**DRAFT CB XX-XX**

**ORDINANCE NO. XX**

**AMENDMENTS TO VOLUME 2, POLICIES AND VOLUME 3,  
 DEVELOPMENT CODE OF THE GRESHAM COMMUNITY DEVELOPMENT  
 PLAN, REGARDING PHASE ONE OF THE DEVELOPMENT CODE AND  
 PROCESS UPDATES (DCPU) PROJECT**

**Figure: ~~Urban Commercial~~ Downtown Local cross-section**

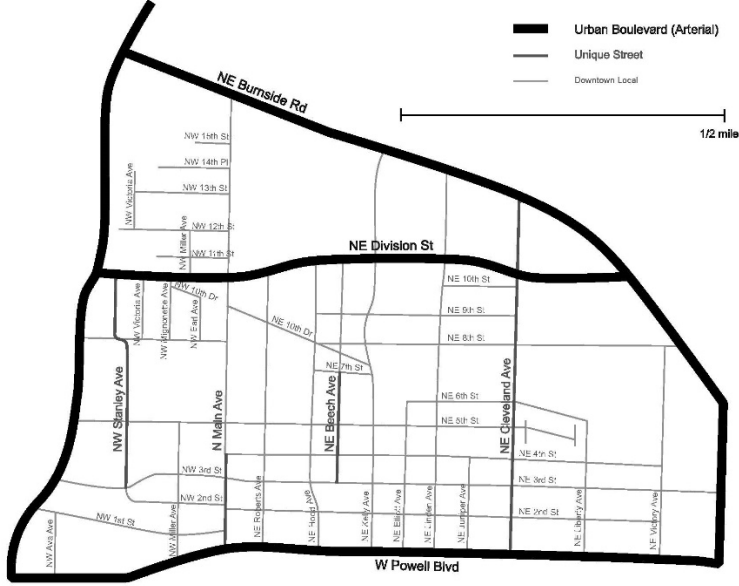
*Typo correction.*

**Map 4.1243: Civic Neighborhood Streets and Future Streets**

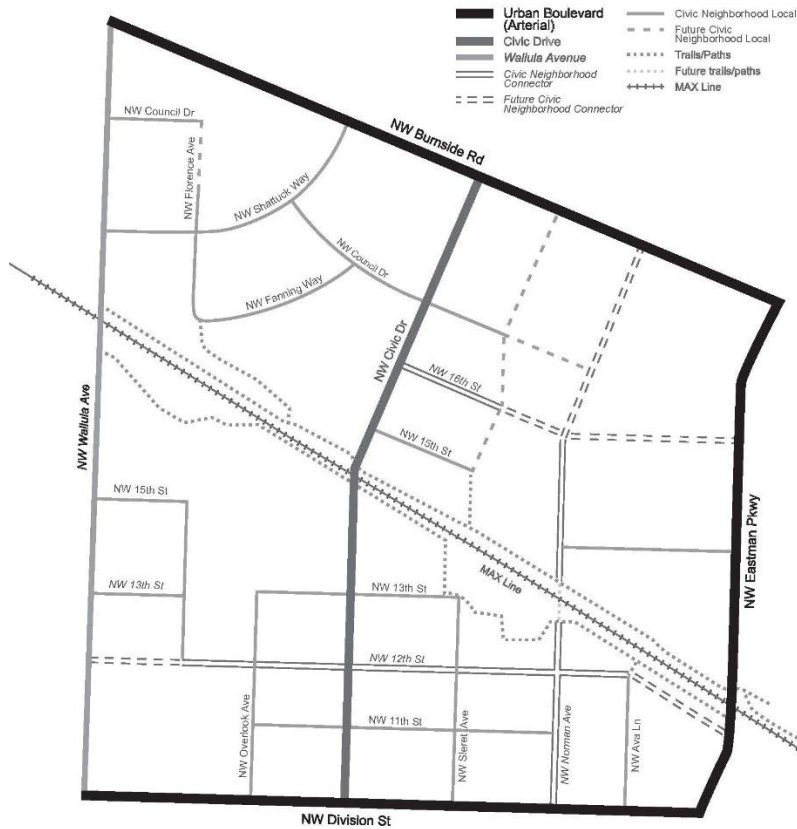
<p>***</p> <p><b>4.1240 Civic Neighborhood Streets</b></p> <p>***</p>	<p><i>Update map format for legibility and clarify trails/paths.</i></p>

*Policy clarification.*

Map 4.1243 Note: Any unclassified or future street bounded by Burnside, Eastman, Division and Wallula, shall be classified as Civic Neighborhood Local streets. Any unclassified street outside of that boundary shall be classified and dimensioned per the Transportation System Plan and shall meet the frontage, setback, and street type of the Urban Boulevard or Civic Neighborhood Local, whichever is more similar.

**Diagram E.1: Civic Neighborhood Local Street Type Cross Section**

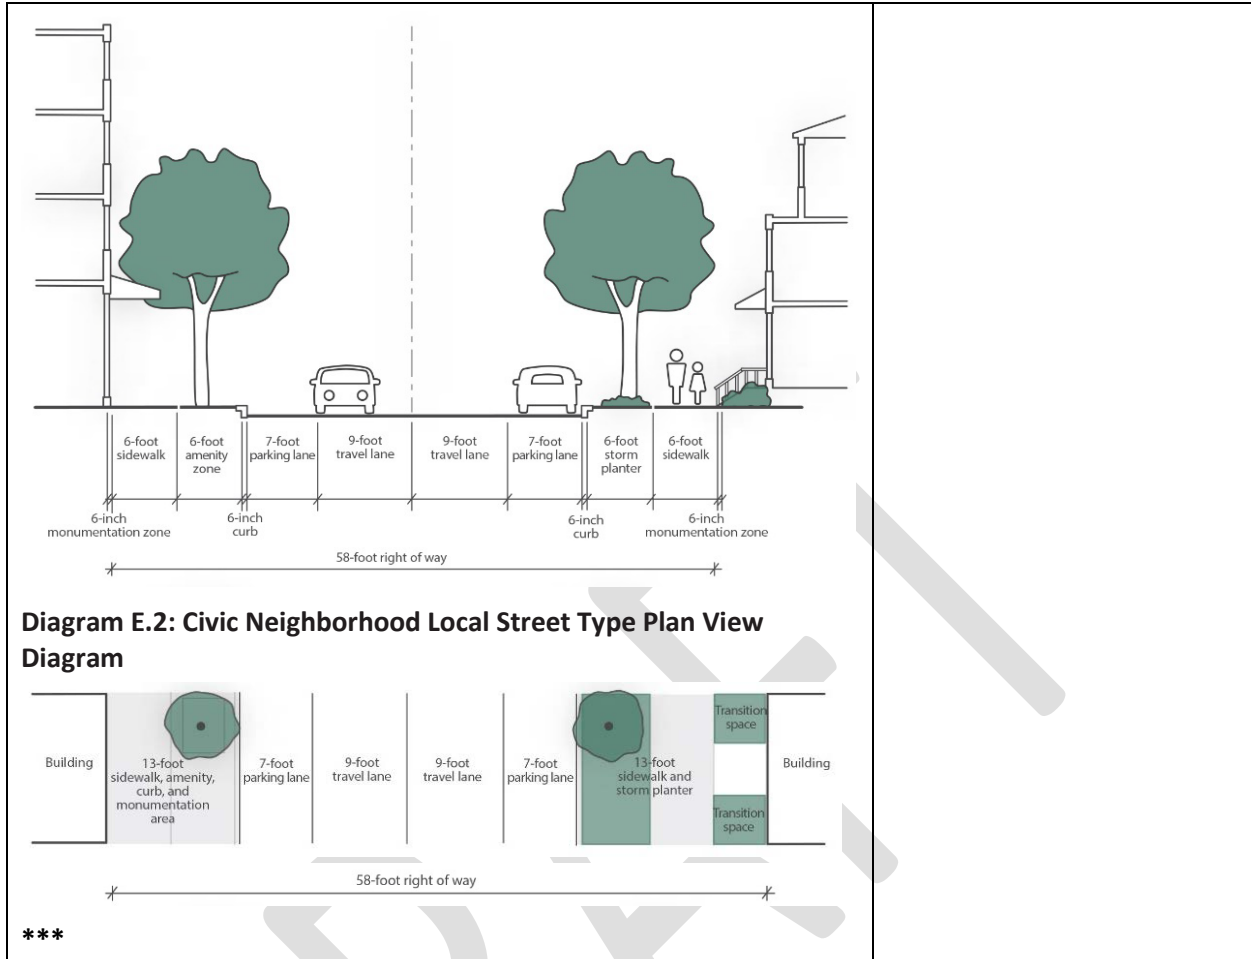
*Update cross-section travel lanes from 11 ft. to 9 ft. and sidewalk amenity zones from 11 ft. to 13 ft. for greater pedestrian orientation.*

*Update plan view travel lanes from 11 ft. to 9 ft. and sidewalk amenity zones from 11 ft. to 13 ft. for greater pedestrian orientation.*
